Subject: FAQ 17 status
Creation Date 5/3/2007 1:30:15 PM
From: Charles Moulton

Please find the attached revision 5 to FAQ 06-0008 for submittal. Two versions are included showing both changes hidden and changes shown. If you have any questions please give me a call.

Plant: Harris

**Attachment to FAQ 06-0012 Revision 3
Excerpt from NEI 04-02 Revision 1 with Changes Tracked**

Figure B-4 General Process to Transition Operator Manual Actions

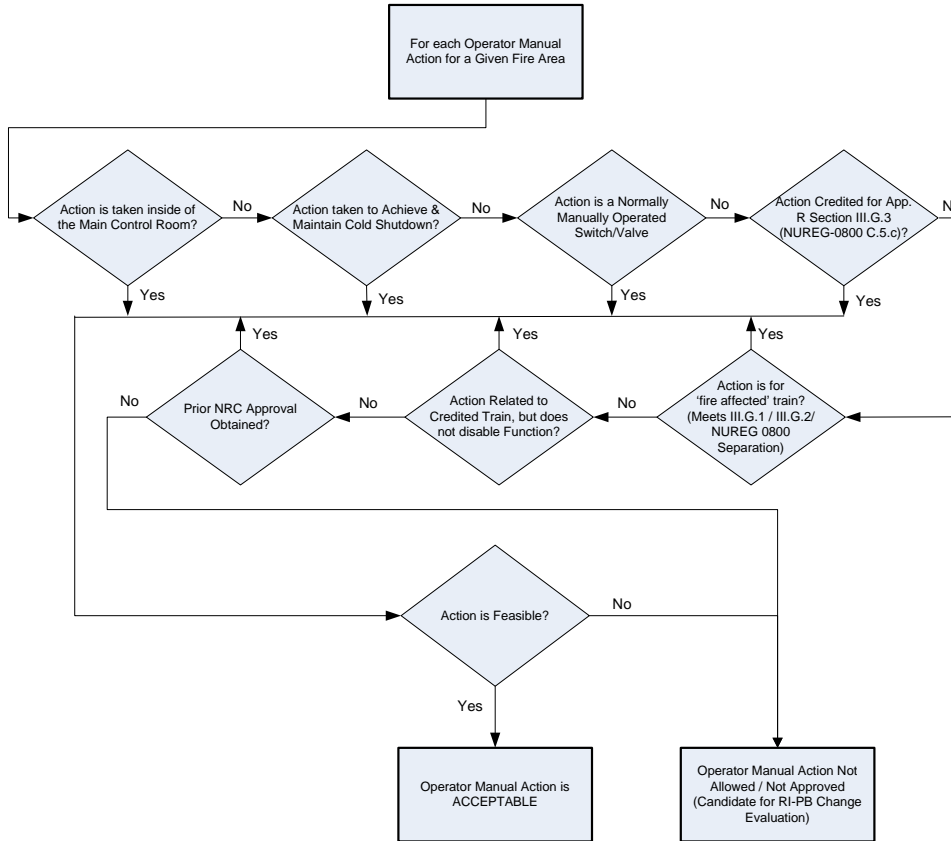
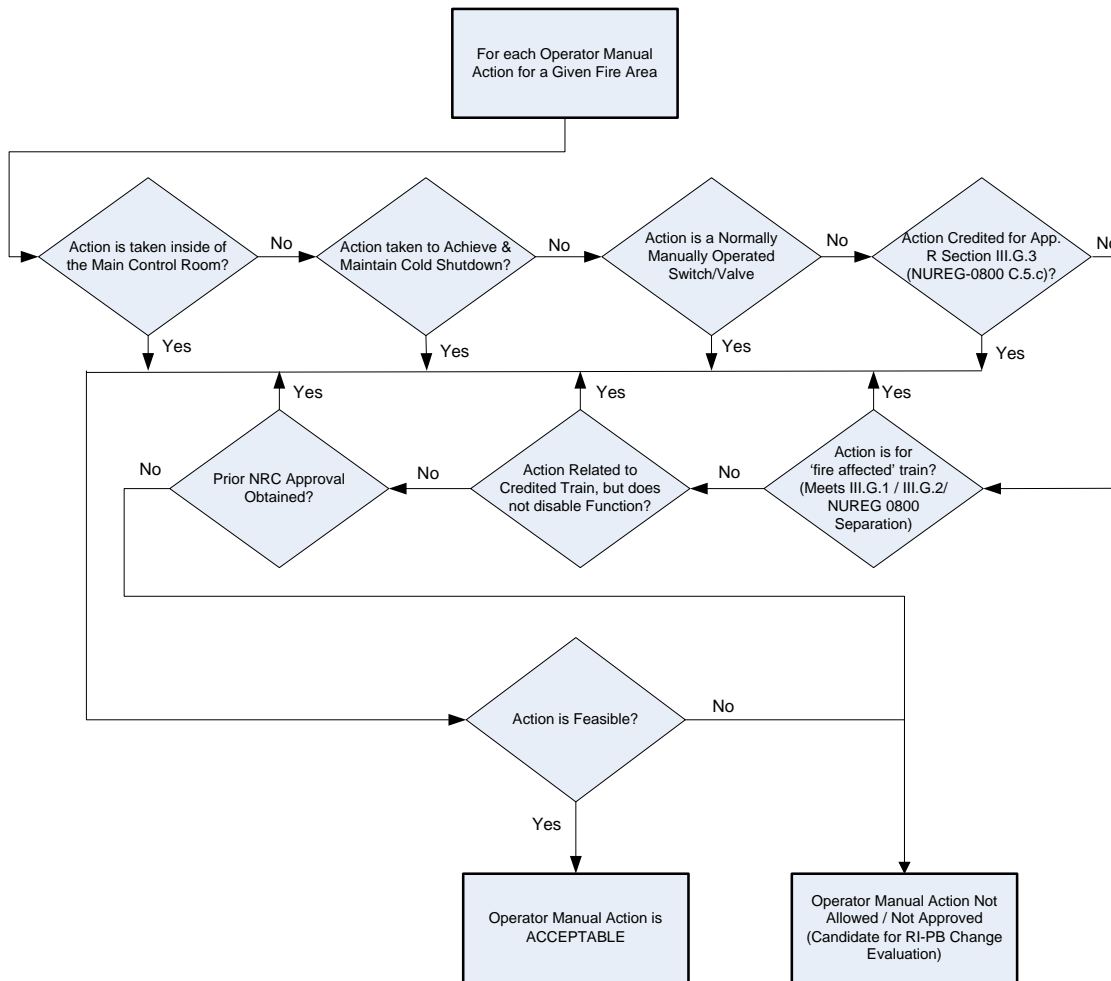
Figure B-4 depicts this general process for determining whether a transitioning operator manual action to NFPA 805 recovery action requires a change evaluation.

Figure B-5 Allowed Operator Manual Action in Fire Area Meeting 10 CFR 50, Appendix R, Section III.G.1 Separation Criteria

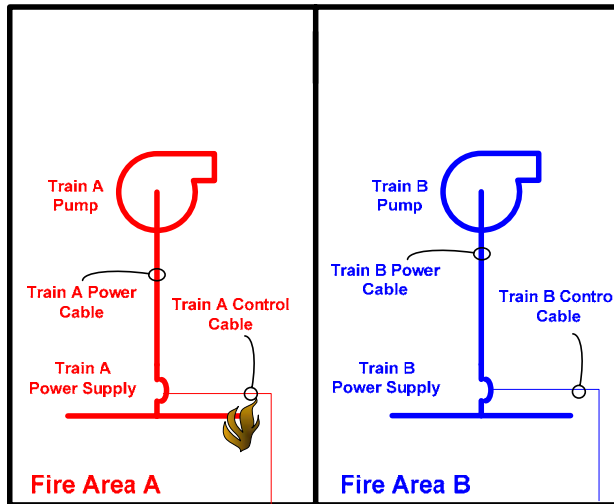
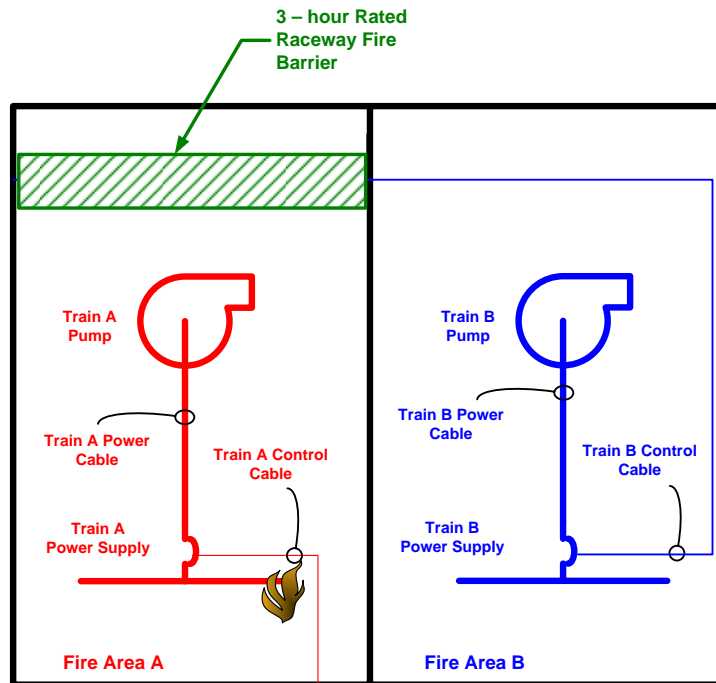
- Operation of fire affected equipment for fire areas that meet the separation requirements of Section III.G.1 of 10 CFR 50, Appendix R (or applicable sections of NUREG-0800). See Figure B-5.

- Operation of fire affected equipment for fire areas that meet the separation requirements of Section III.G.1 of 10 CFR 50, Appendix R (or applicable sections of NUREG-0800). See Figure B-5.

Figure B-6 Allowed Operator Manual Action in Fire Area Meeting 10 CFR 50, Appendix R, Section III.G.2 Compliant – Operator Manual Action for Fire Affected Train

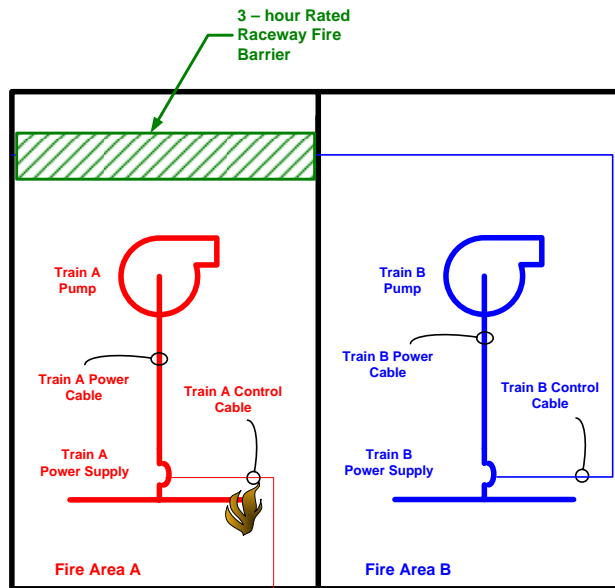
- Operation of fire affected equipment for fire areas that meet the protection requirements of Section III.G.2 of 10 CFR 50, Appendix R (or applicable sections of NUREG-0800) for redundant trains. See Figure B-6.

Fire Area B meets the separation criteria of 10 CFR 50 Appendix R Section III.G.2.a. A postulated fire in Fire Area A could result in the spurious starting of the non-credited Train A pump, which can be mitigated by an operator manual action to de-energize the Train A Power Supply to stop Pump A. This is functionally equivalent to Case in Figure B-5.

Figure B-7. Allowed Operator Manual Action – In Credited Success Path – Common Tank Suction

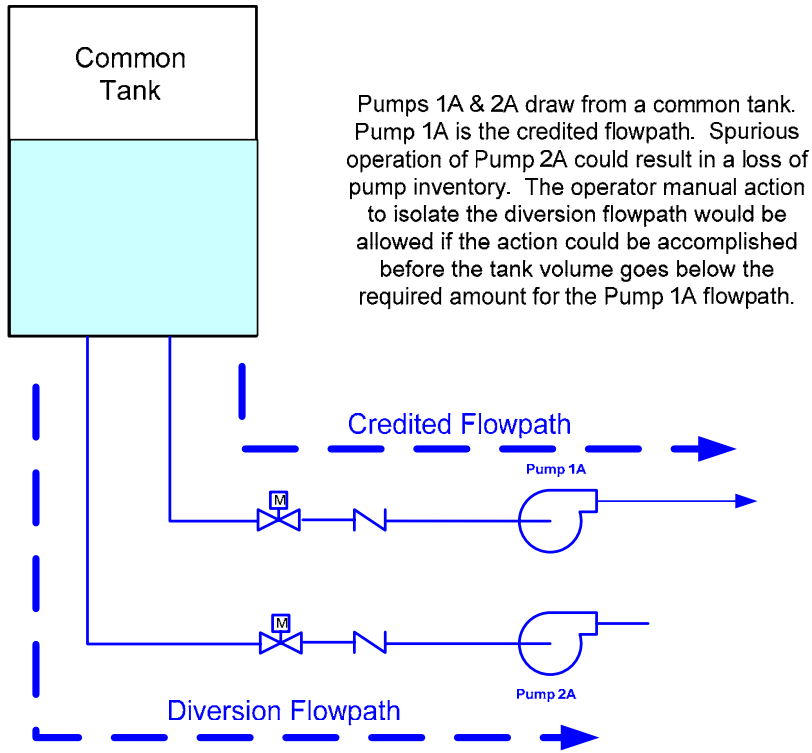
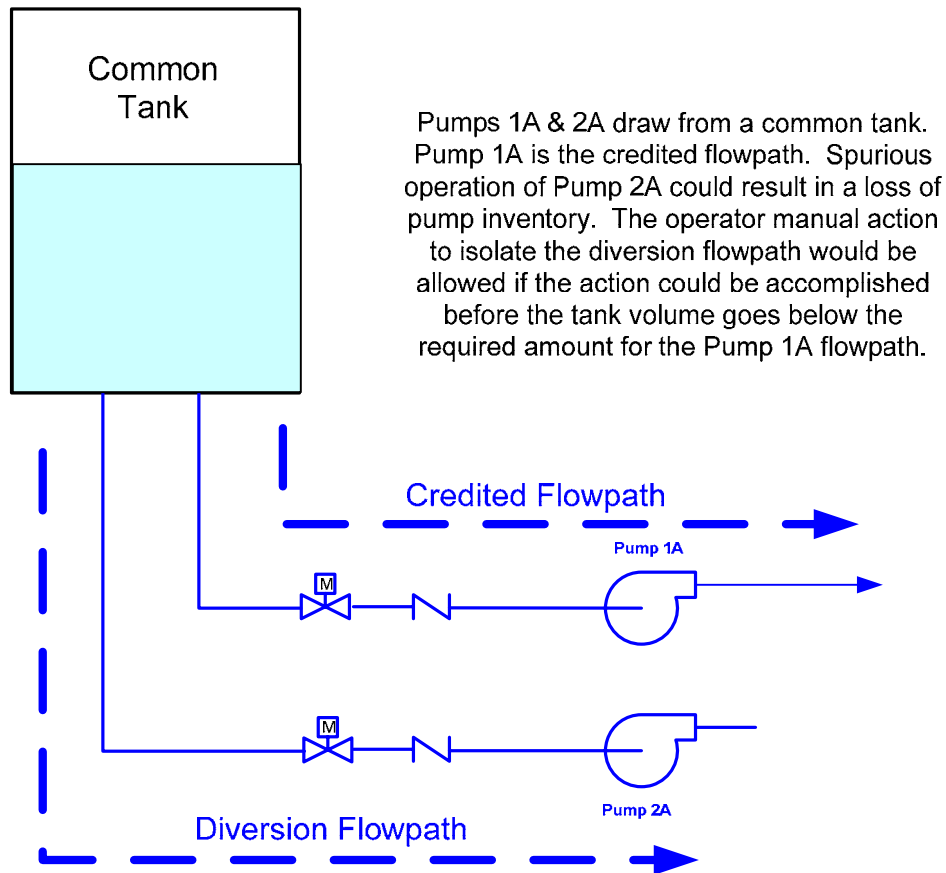
During the June 9, 2006 public meeting the following example was specifically discussed: Two redundant trains taking suction from a common tank. Provided the manual action can be accomplished prior to the tank volume going below the minimum required volume to support the credited function the action would be allowed and therefore not require a change evaluation. (Figure B-7)

During the June 9, 2006 public meeting the following example was specifically discussed: *Two redundant trains taking suction from a common tank. Provided the manual action can be accomplished prior to the tank volume going below the minimum required volume to support the credited function the action would be allowed and therefore not require a change evaluation.* (Figure B-7)

Figure B-8, Allowed Operator Manual Action – In Credited Success Path – Auxiliary Feedwater Flow Diversion

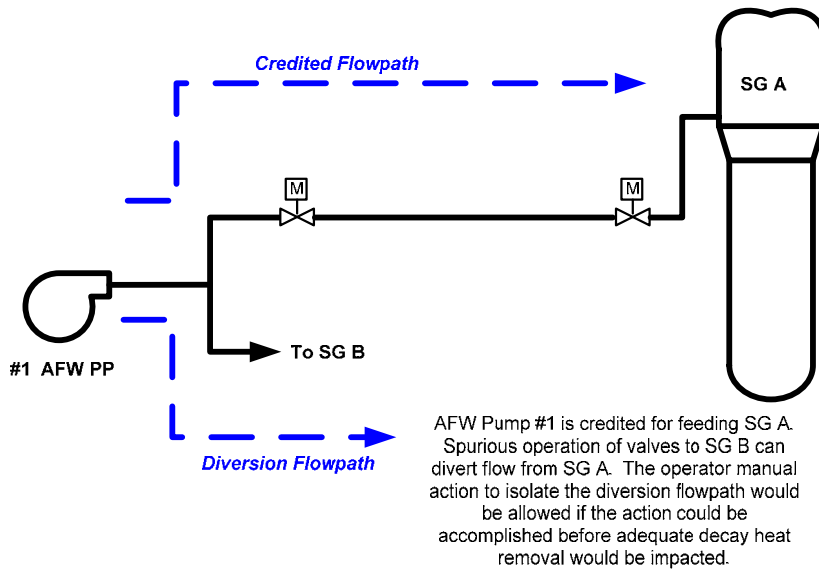
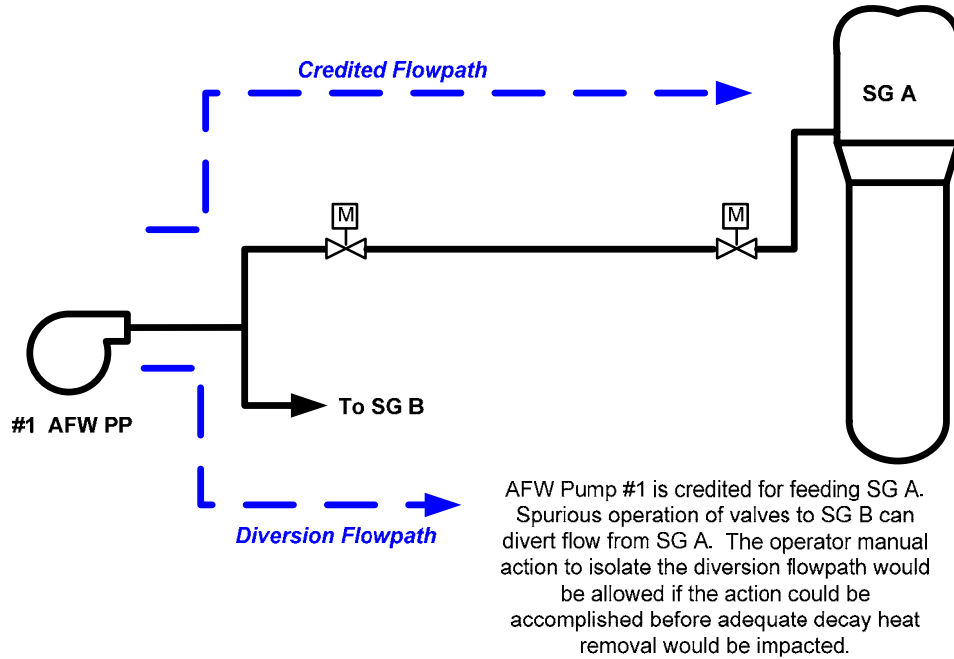
A second example is the credited function is to inject water to the Steam Generator (reactor) and a spurious actuation causes a diversion from the credited flow path. Provided the minimum required injection flow can be maintained and the operator action can be accomplished prior to the function being disabled. (Figure B-8)

A second example is the credited function is to inject water to the Steam Generator (reactor) and a spurious actuation causes a diversion from the credited flow path. Provided the minimum required injection flow can be maintained and the operator action can be accomplished prior to the function being disabled. (Figure B-8)
